## REQUEST FOR COUNCIL ACTION

| ITEM DESCRIPTION: General Development Plan # 205 by Arcon Development, Inc. to be known as Hart Farm South. The Applicant is proposing to develop approximately 80 acres of land located along the north side of 40 <sup>th</sup> Street SW and along the west side of 18 <sup>th</sup> Avenue SW with single family homes, townhomes and neighborhood commercial uses. The property is proposed to be served by public roads. An Annexation petition for the entire property, and a Zoning District Amendment for a portion of this property are being considered concurrent with this petition. |                               | PREPARED BY:<br>Theresa Fogarty,<br>Planner |

**REVISED**  
**GENERAL DEVELOPMENT PLAN**  
 HART FARM SOUTH

**RE: General Development Plan #205 by Arcon Development, Inc., to be known as Hart Farm South. The Applicant is proposing to develop approximately 80 acres of land located along the north side of 40<sup>th</sup> Street SW and along the west side of 18<sup>th</sup> Avenue SW with single family homes, townhomes and neighborhood commercial uses. The property is proposed to be served by public roads. An Annexation petition for the entire proper

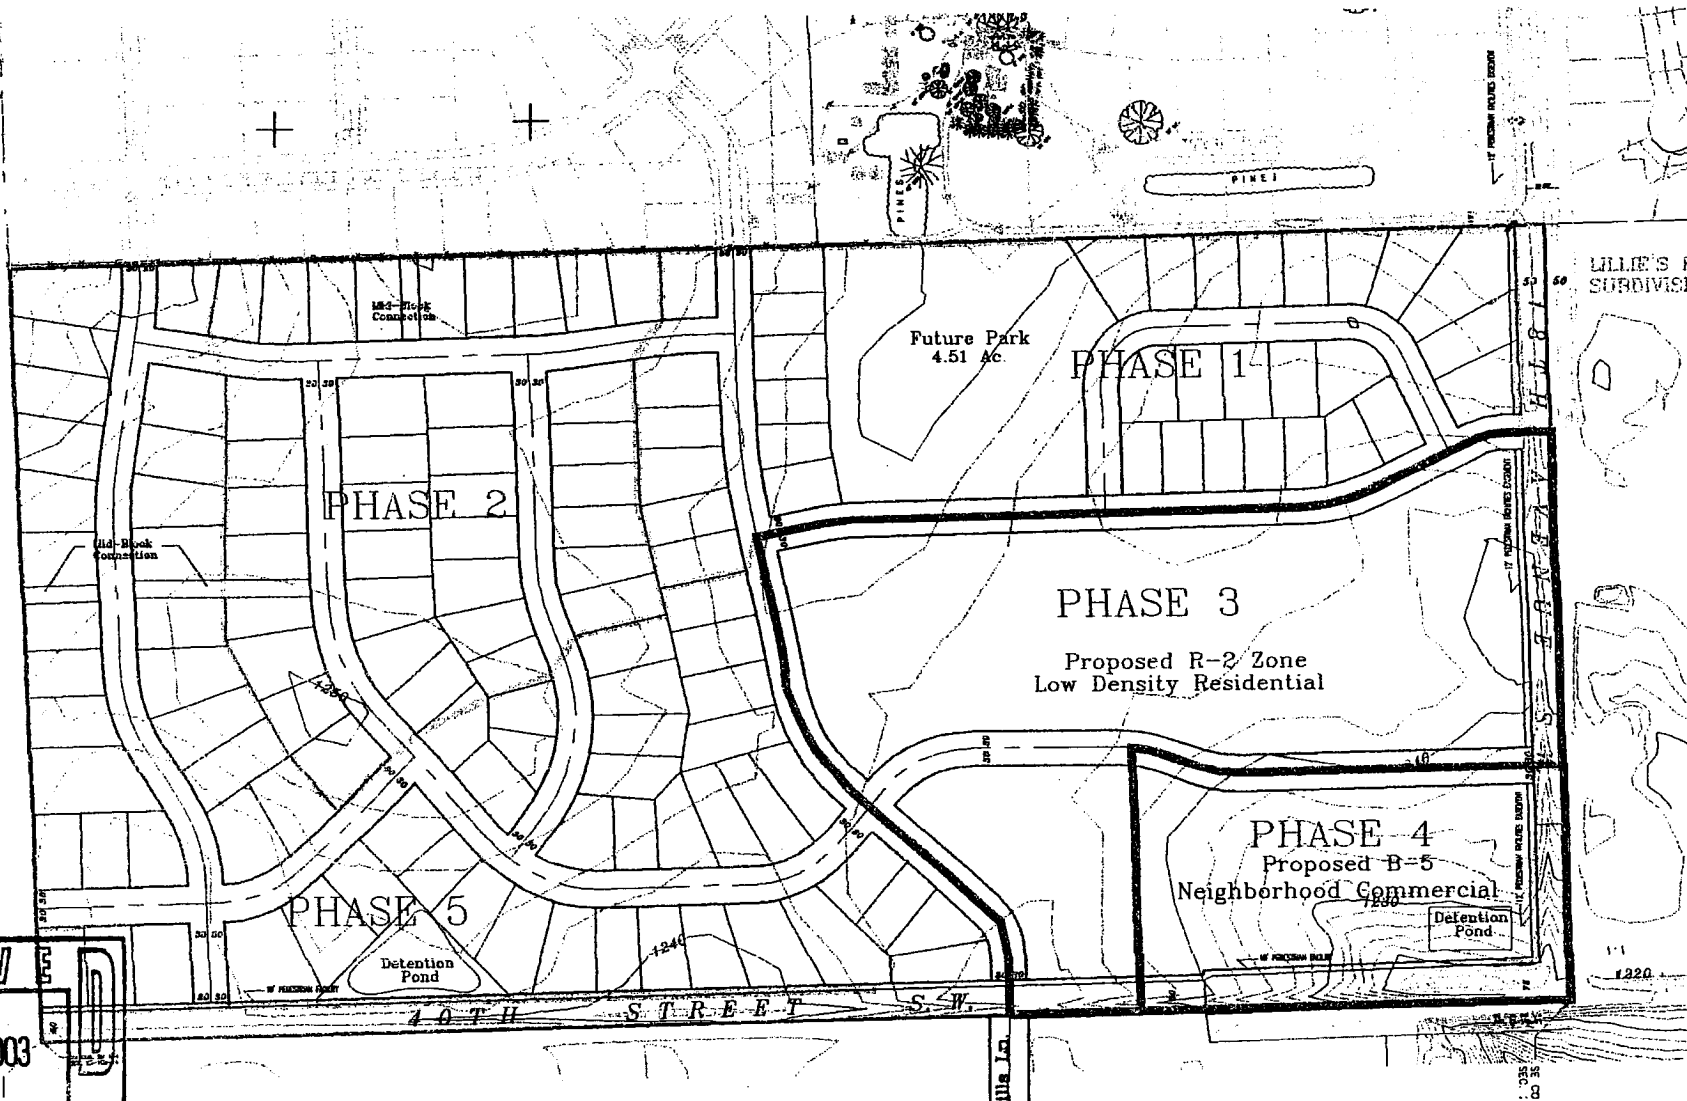
*Please Note: The applicant submitted a revised General Development Plan, therefore, staff is recommending Conditions 1- c & 1-d listed in the General Development Staff report, be deleted. Text to be deleted will be shown as ~~stikeout-text~~. Conditions 1-a & 1-b are being discussed with staff and will be addressed during the platting process.*

- a) Dedication of a 60' ROW along the westerly frontage of 18<sup>th</sup> Avenue SW and northerly frontage of 40<sup>th</sup> Street SW.
- b) Dedication of the 60' ROW shall include sufficient area to construct the required pedestrian facilities within the right-of-way. Identify and label the required 10' wide pedestrian facilities within the right-of-way along the westerly frontage of 18<sup>th</sup> Avenue SW and northerly frontage of 40<sup>th</sup> Street SW.
- c) ~~The proposed public street intersection with 40<sup>th</sup> Street SW, at the westerly edge of proposed Phase 3, shall be revised to align across from Windsor Hills Lane SW.~~
- d) ~~Increase the size of the park by 4.0 acres.~~

- c) *It appears that several of the blocks located within Phase 2 may exceed 800' in length, thereby requiring additional mid-block connections. Staff will address the need for additional mid-block pedestrian connections. The Owner shall be required to dedicate any mid-block pedestrian connections on separate Outlots and construct the required pedestrian path connections with the Outlots.*
